ATTACHMENT 1

PROPOSED TECHNICAL SPECIFICATION CHANGE

FIGURE 3.12-1A CONTROL BANK INSERTION LIMITS FOR 3-LOOP
NORMAL OPERATION-UNIT 1

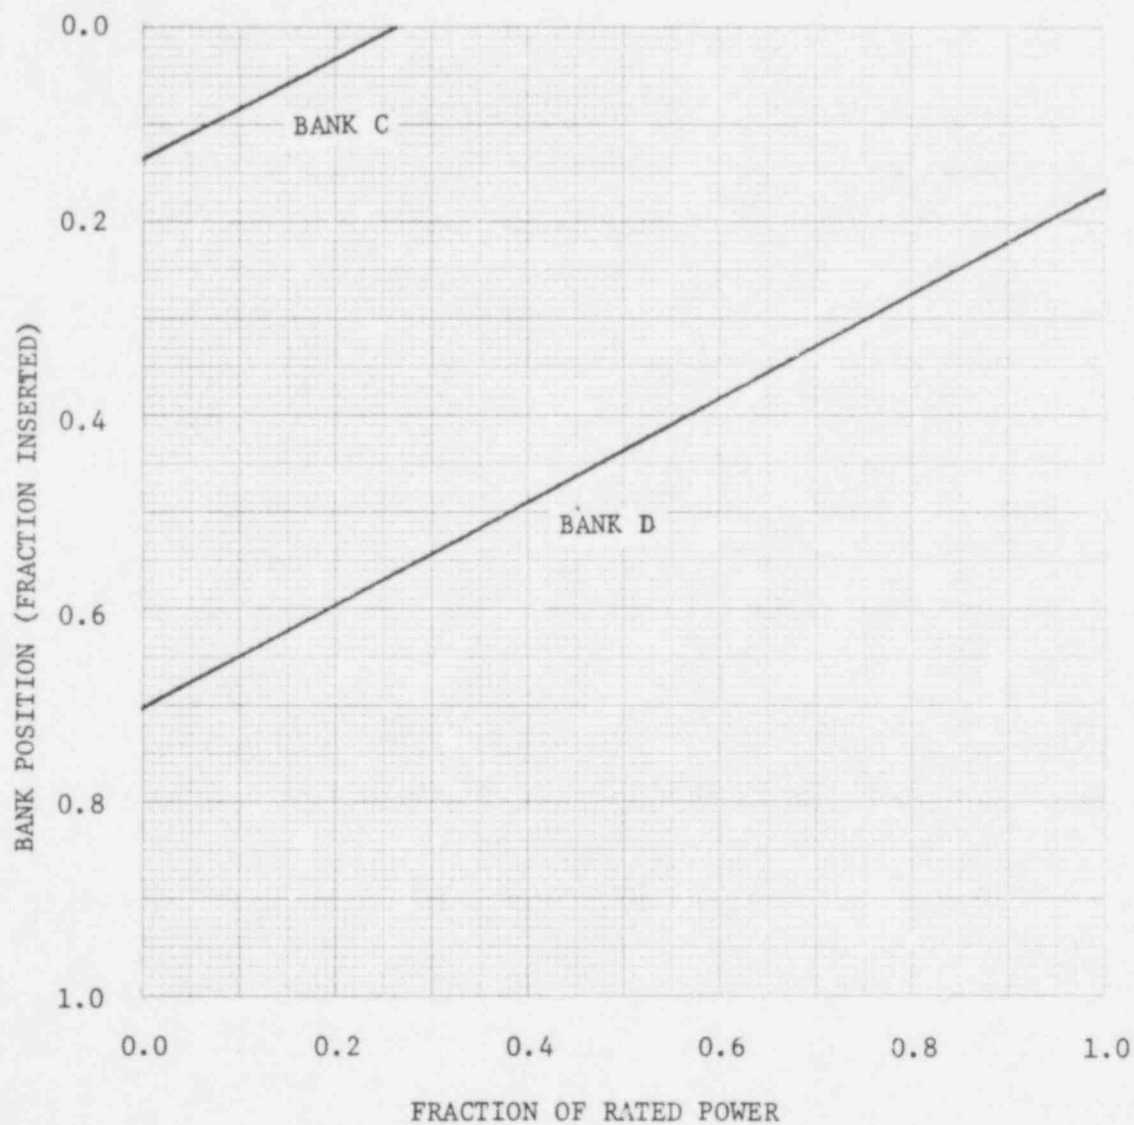
on the maximum inserted rod worth in the unlikely event of a hypothetical assembly ejection and provide for acceptable nuclear peaking factors. The limit may be determined on the basis of unit startup and operating data to provide a more realistic limit which will allow for more flexibility in unit operation and still assure compliance with the shutdown requirement. The maximum shutdown margin requirement occurs at end of core life and is based on the value used in the analysis of the hypothetical steam break accident. The rod insertion limits are based on end of core life conditions. The shutdown margin for the entire cycle length is established at 1.77% reactivity. All other accident analysis with the exception of the chemical and volume control system malfunction analysis are based on 1% reactivity shutdown margin. Relative positions of control rod banks are determined by a specified control rod bank overlap. This overlap is based on the consideration of axial power shape control. The specified control rod insertion limits have been established to limit the potential ejected rod worth in order to account for the effects of fuel densification. The Unit 1 limits have been raised as shown in Figure 3.12-1A to ensure acceptable radial power peaking during Cycle 7 core life. The various control rod assemblies (shutdown banks, control banks A, B, C, and D) are each to be moved as a bank; that is, with all assemblies in the bank within one step (5/8 inch) of the bank position. Position indication is provided by two methods: a digital count of actuating pulses which shows the demand position of the banks, and a linear position indicator, Linear Variable Differential Transformer, which indicates the actual assembly position. The position indication accuracy of the Linear Differential Transformer is approximately $\pm 5\%$ of span (± 12 steps) under steady state conditions. The relative accuracy of the linear position indicator has been considered in establishing the maximum allowable deviation of a control rod assembly from its indicated group step demand position. In the event that the linear position indicator is not
